QUESTIONS from Geosciences and Geotechnical Engineering Branch 1 (RGS1)

FPL RESPONSE:

Proposed Turkey Point Units 6 and 7
Docket Nos. 52-040 and 52-041
FPL Revised Response to NRC RAI No. 02.05.04-19 (eRAI 6006)
L-2014-111 Attachment 18 Page 30 of 35

Proposed Turkey Point Units 6 and 7
Docket Nos. 52-040 and 52-041
FPL Revised Response to NRC RAI No. 02.05.04-20 (eRAI 6006)
L-2014-111 Attachment 19 Page 9 of 9

Figure 5 Estimated Locations of FD4 Zones

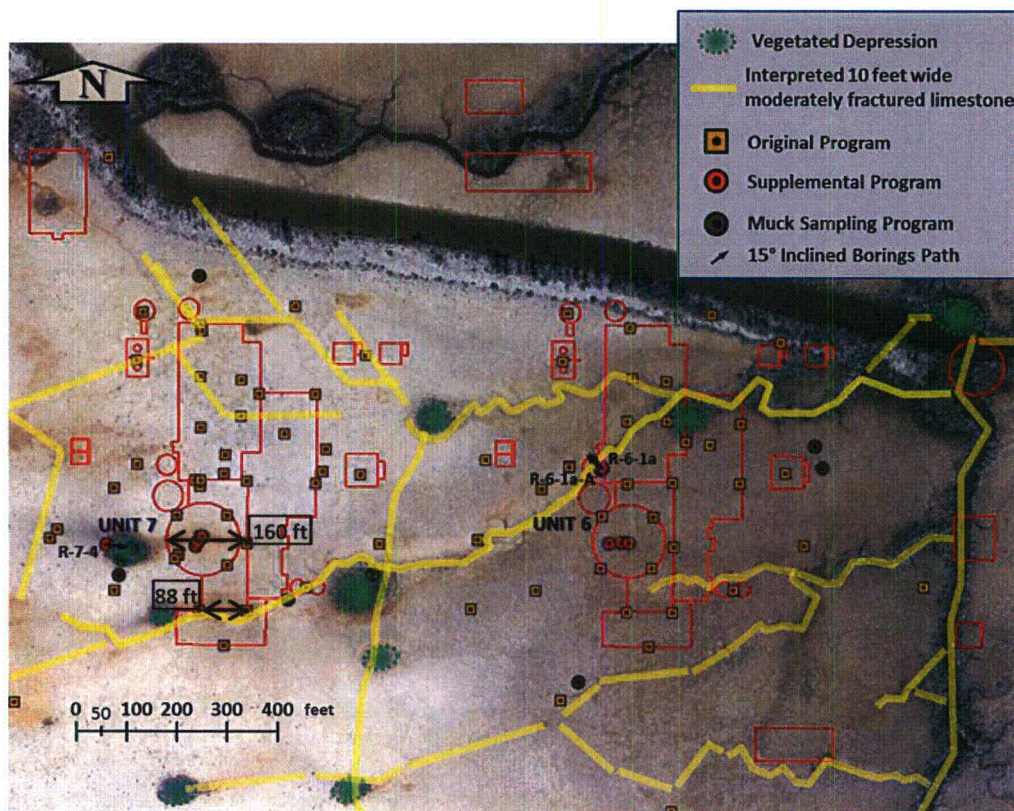
In SLOPE/W, a case is considered where zones representing open discontinuities are placed beneath and to the side of the NI to represent zones of FD4 material as shown in Figure 5. This case is unrealistic because joints in FD4 rock are only moderately open, but is presented to show an extreme case that still meets the bearing demand criteria.

Figure 7 Simulated Discontinuities, 1x Required Bearing Demand

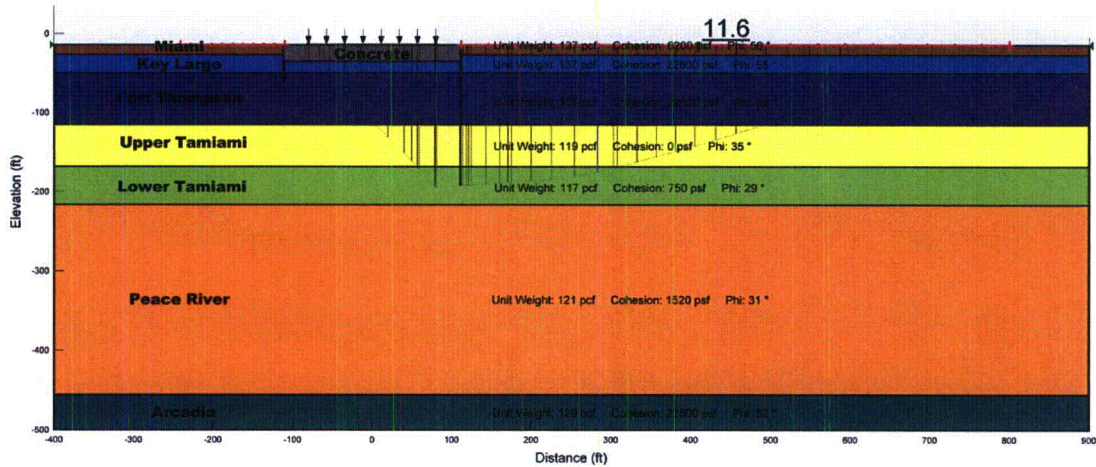
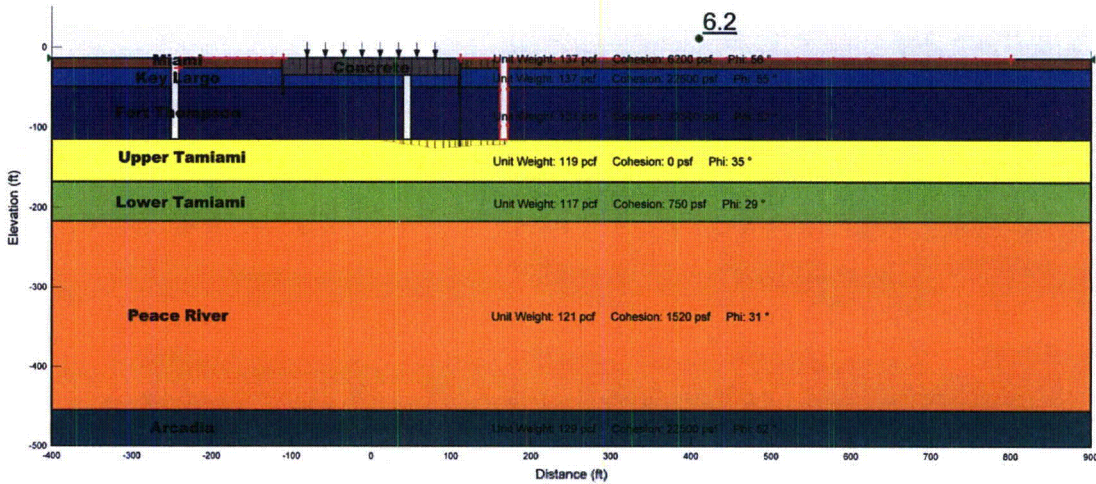
In SLOPE/W, the extreme case of simulated FD4 zones is evaluated differently than the other SLOPE/W cases, by finding the factor of safety when the bearing demand pressure of 8.9 ksf is applied instead of finding the allowable bearing capacity for a prescribed factor of safety. The following failures are found for configurations with and without simulated FD4 zones (Figures 6 and 7).

The factor of safety with simulated FD4 zones (FS = 6.2) is almost half of the factor of safety with no FD4 zones (FS = 11.6). This low factor of safety is still more than double the required FS=3.0

Figure 8 Plastic Deformation from PLAXIS 2D Analysis, 1x Required Bearing Demand

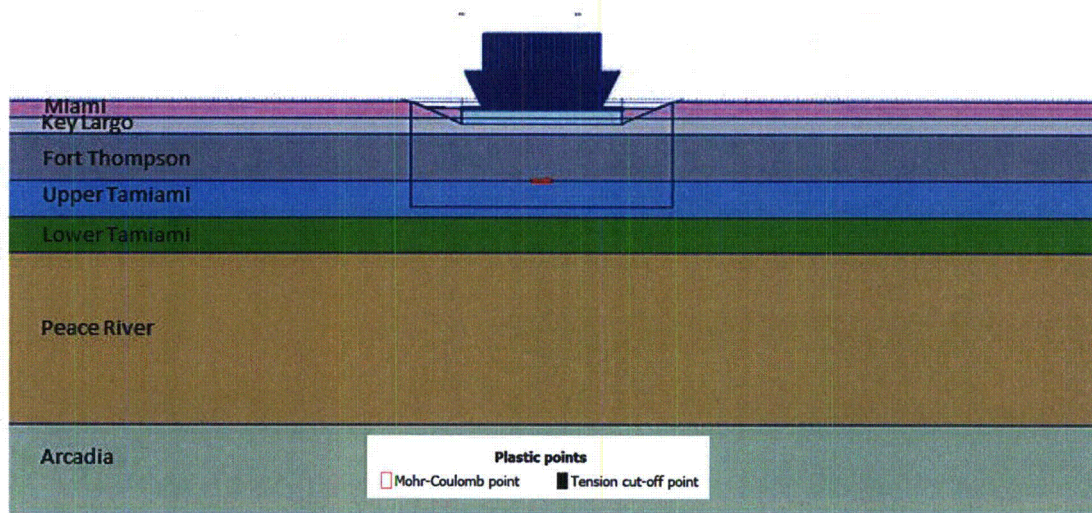
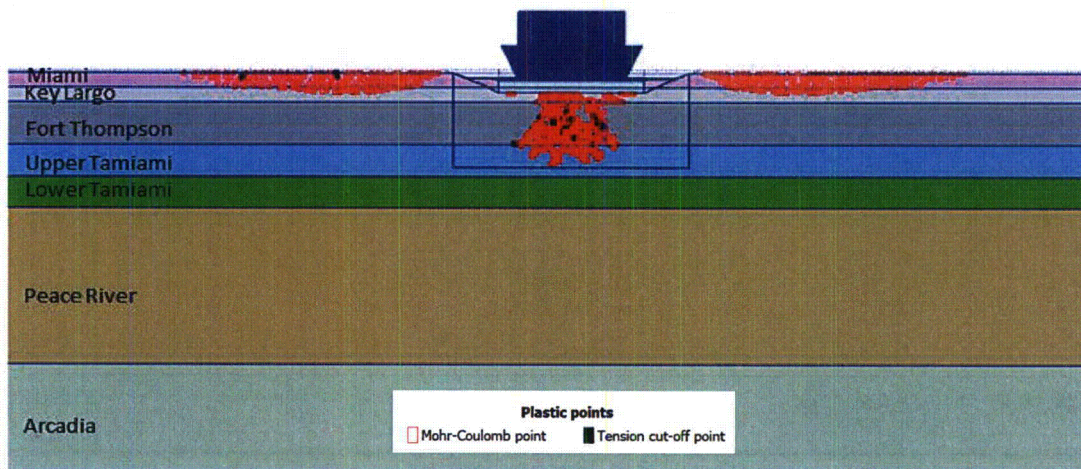
In PLAXIS 2D, the beam tension failure is checked for the required bearing demand (8.9 ksf) as well as three times the required bearing demand (26.7 ksf). In Figures 8 and 9, points in tension are shown with black circles. As evident in both cases, there are minimal black circles, i.e., no tensile failure is observed.

Figure 1. PLAXIS 3D Design Mesh

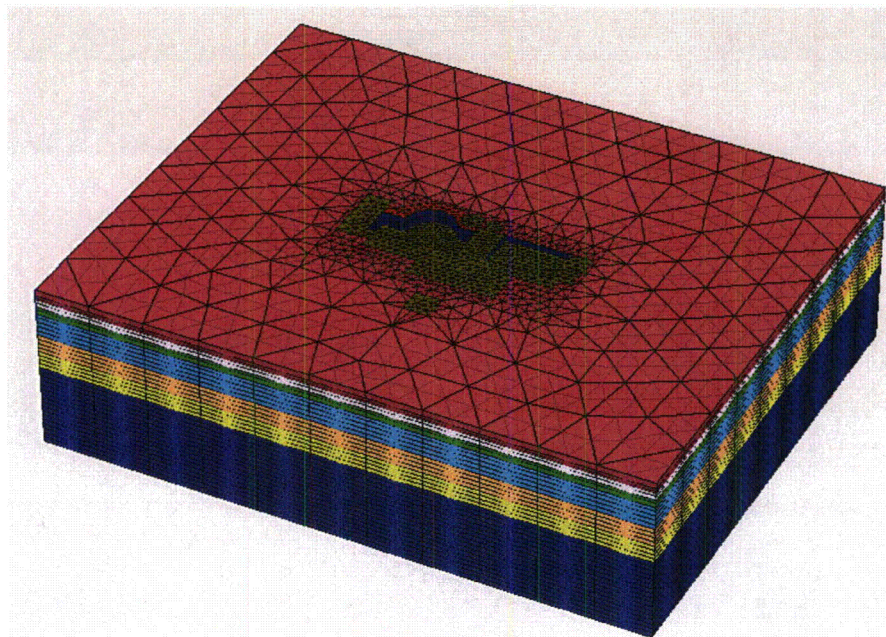
Four models with the following numbers of elements are considered: Very Coarse – 11,514, Moderately Coarse – 25,650, Design – 70,152 and Finest – 115,810. The change in mesh density for these models is focused on the loaded areas. Both vertical and horizontal meshes are varied. These models have the best estimate material properties (slightly fractured [FD1], for rock). Figure 1 shows the design mesh.

Figure 6 PLAXIS 3D Best Estimate Model Total Settlement After Loading

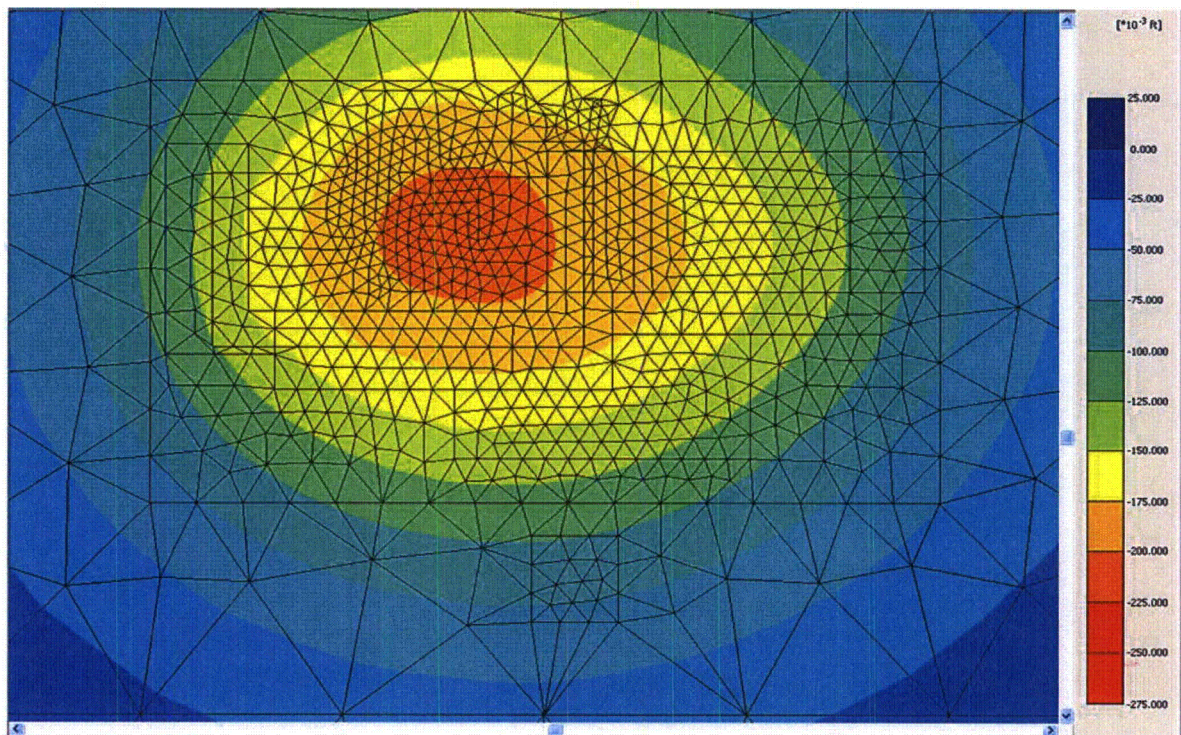
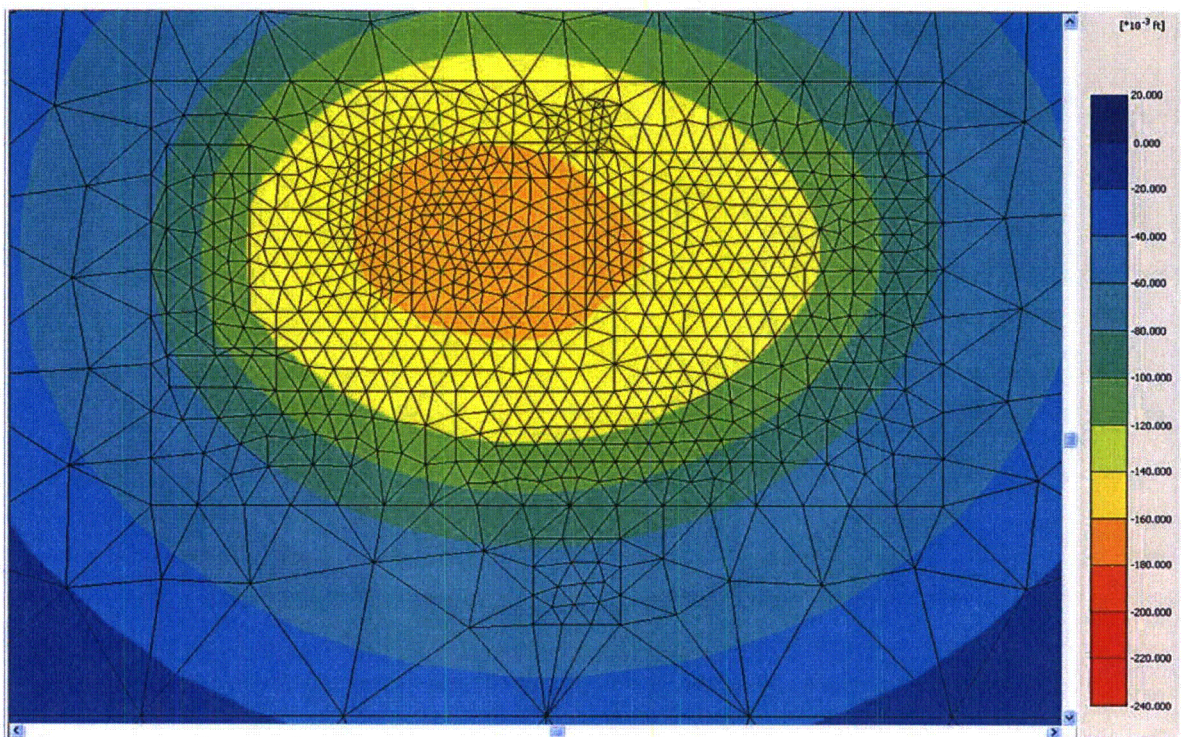
The sensitivity analyses presented in Tables 1 and 2 demonstrate that the best estimate model used is appropriate. Figure 6 shows the PLAXIS 3D total displacement output for the best estimate model after the loading of the NI. Figure 7 shows the PLAXIS 3D total displacement output for the best estimate model after rewatering.

Figure 3 Comparison of Stress Distributions

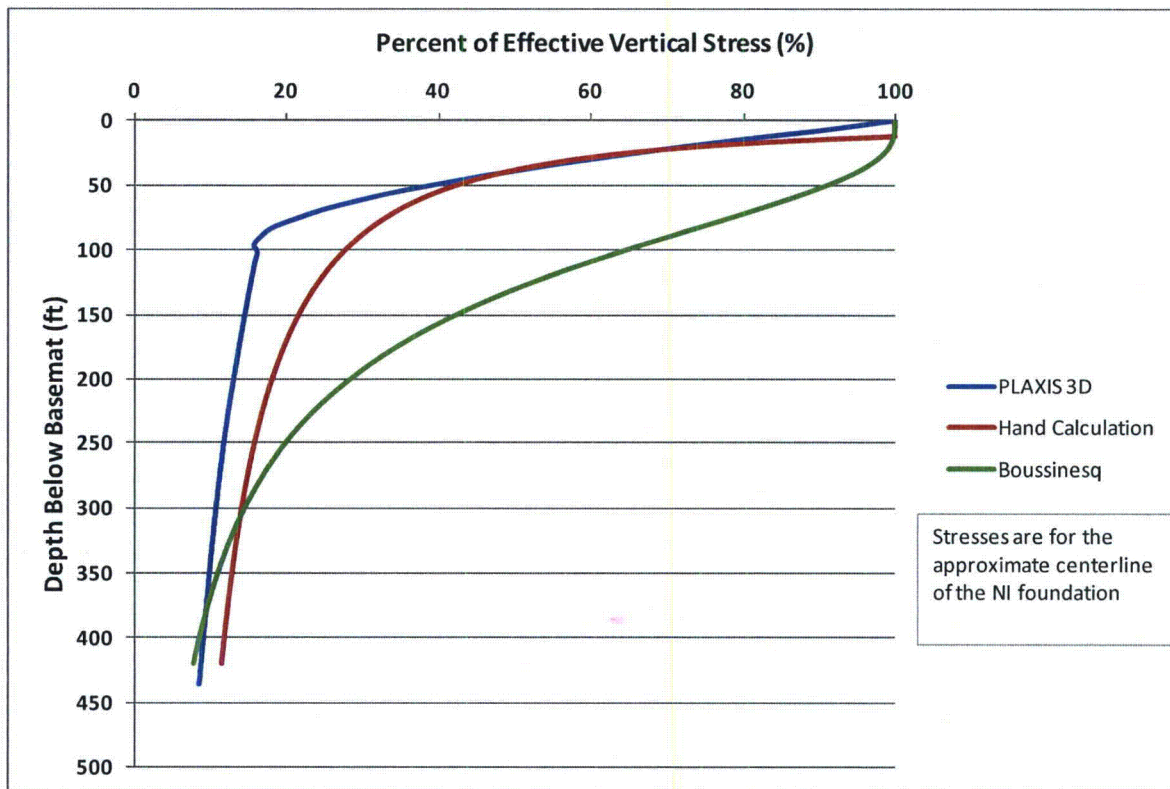
FSAR Subsection 2.5.4.10.3 indicates that the stress distribution used for the settlement calculation was based on Boussinesq distribution. The Boussinesq distribution is based on the assumption that the soil is a homogeneous, linear elastic, isotropic half-space media. In accordance with NUREG-0800, Standard Review Plan, Chapter 2.5.4, "Stability of Subsurface Materials and Foundations," please justify how this method is applicable for the site since a considerable variation in Elastic modulus was reported in the FSAR.

As shown in Figure 3, Boussinesq is highly conservative as it estimates higher stresses in both the rock and soil layers. The stress distribution found by using Reference 1 is similar to but more conservative than the PLAXIS 3D stress distribution. The difference between the PLAXIS 3D and the Milovic stress distributions can be attributed to the fact that PLAXIS 3D estimates the stresses based on all of the soil and rock strata, while the Milovic stress distribution approximates the system as two layers.

Figure 5 Comparison of Stress Distributions

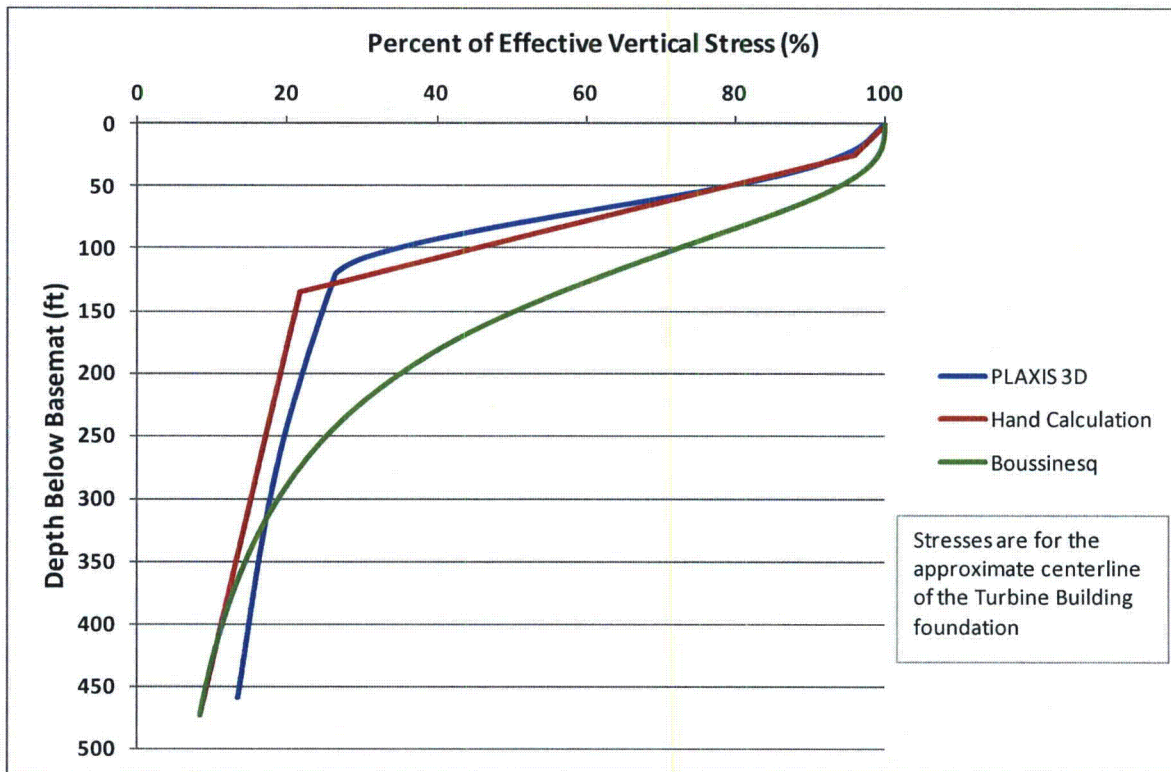
To demonstrate that the stress distribution from Reference 2 is appropriate for the site, the stress distribution of the turbine building is compared to the stress distribution found in PLAXIS 3D as well as Boussinesq (Figure 5).

As shown in Figure 5, Boussinesq is highly conservative by estimating higher stresses in both the rock and soil layers. The stress distribution found by using Reference 2 is very similar to the PLAXIS 3D stress distribution demonstrating that it is appropriate for the settlement calculation.

Figure 1 5% Damping ARS at Ground Surface – Near NI, Envelope of LF and HF

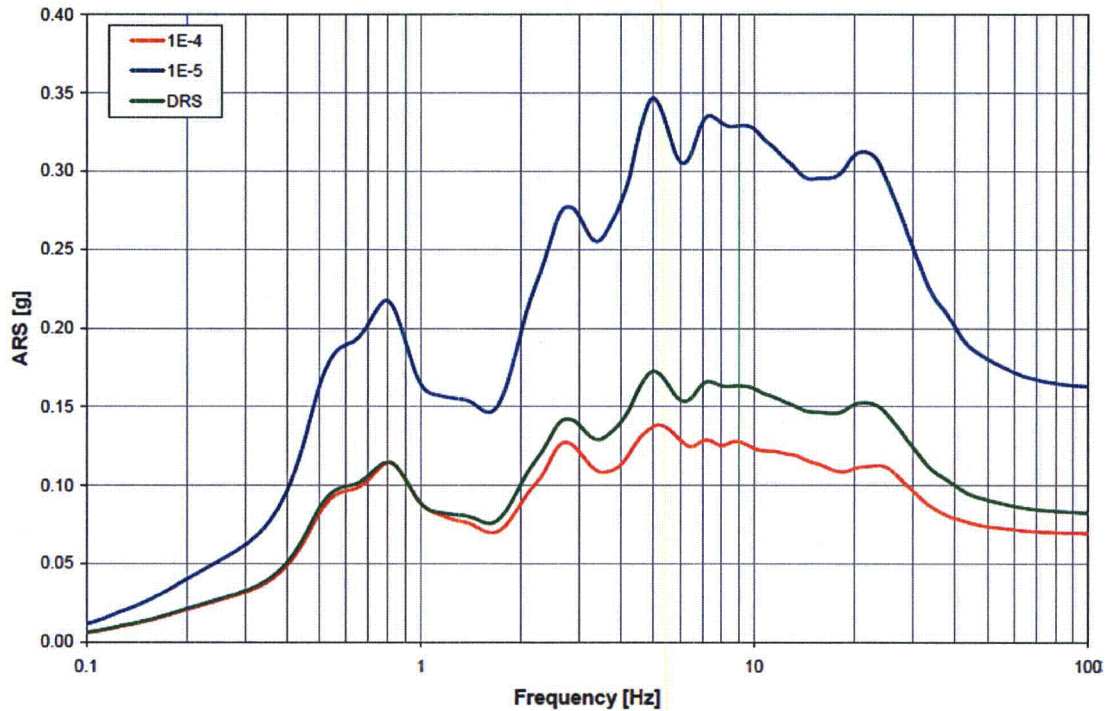
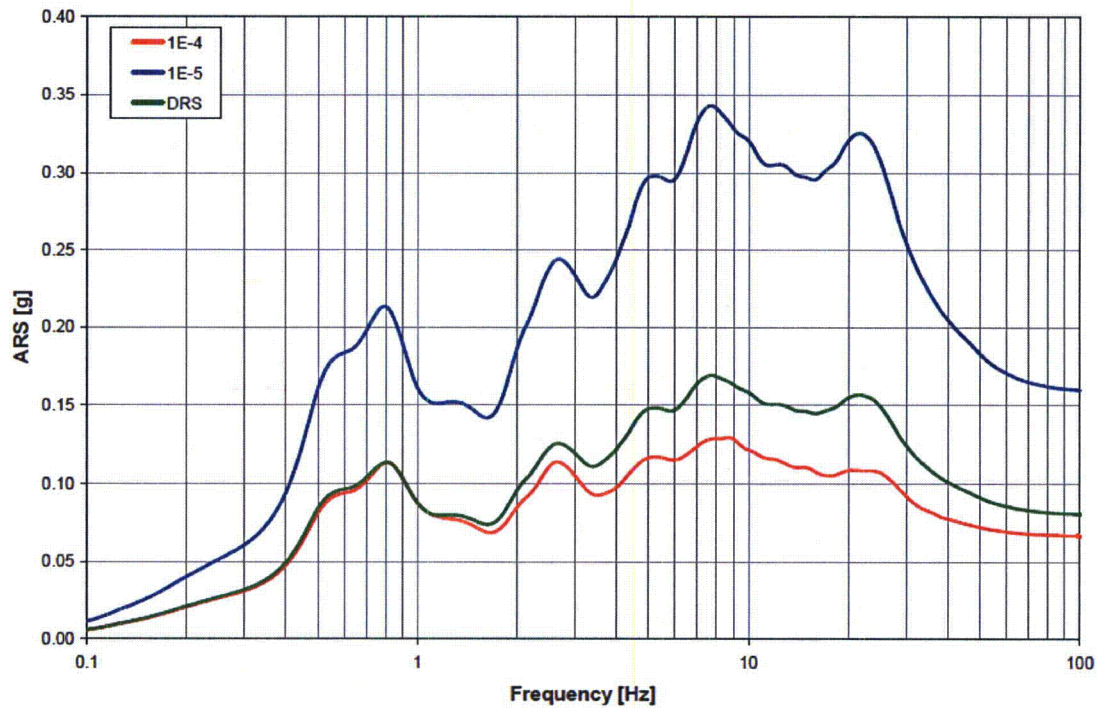
Figure 2.5.2-252 shows the input motion (GMRS) developed for the site, the GMRS is located at Elevation 35. In this Figure the z_{pa} is approximately 0.058g. However, the elevation of the GMRS is considerably lower than the surface of the soils adjacent to the basement walls that are to be evaluated for seismic lateral earth pressure. In accordance with NUREG-0800, Standard Review Plan, Chapter 2.5.4, "Stability of Subsurface Materials and Foundations," please clarify on the definition of the design ground motion, and how that motion is consistent with Appendix S to 10CFR50.

FSAR Figure 2.5.2-253 and FSAR Table 2.5.2-228 show the zero period acceleration (z_{pa}) for the GMRS as about 0.058g. This z_{pa} value was not considered appropriate when computing lateral earth pressure because it was developed for El. -35 feet. The design response spectra (DRS) at 5% damping, calculated at the ground surface for the near nuclear island (NI) and far from NI soil sites, were considered appropriate for computing lateral earth pressure, using the envelope of low frequency (LF) and high frequency (HF) acceleration response spectra (ARS) at 10⁻⁴ and 10⁻⁵ annual probability of exceedance. These ARS envelopes and the DRS are plotted in Figures 1 and 2 for the near NI and far from NI soil sites, respectively. From Figures 1 and 2, the peak ground acceleration at the ground surface is equal to approximately 0.0824g and 0.0806g (DRS at 100 Hertz [Hz]) for the near NI and far from NI soil sites, respectively.

Similarly, for the computation of at-rest seismic pressure using ASCE 4-98 (FSAR Section 2.5.4 Reference 277), an acceleration of 0.1g, rather than the peak ground acceleration of 0.0824g (near NI) or 0.0806g (far from NI), is conservatively used.
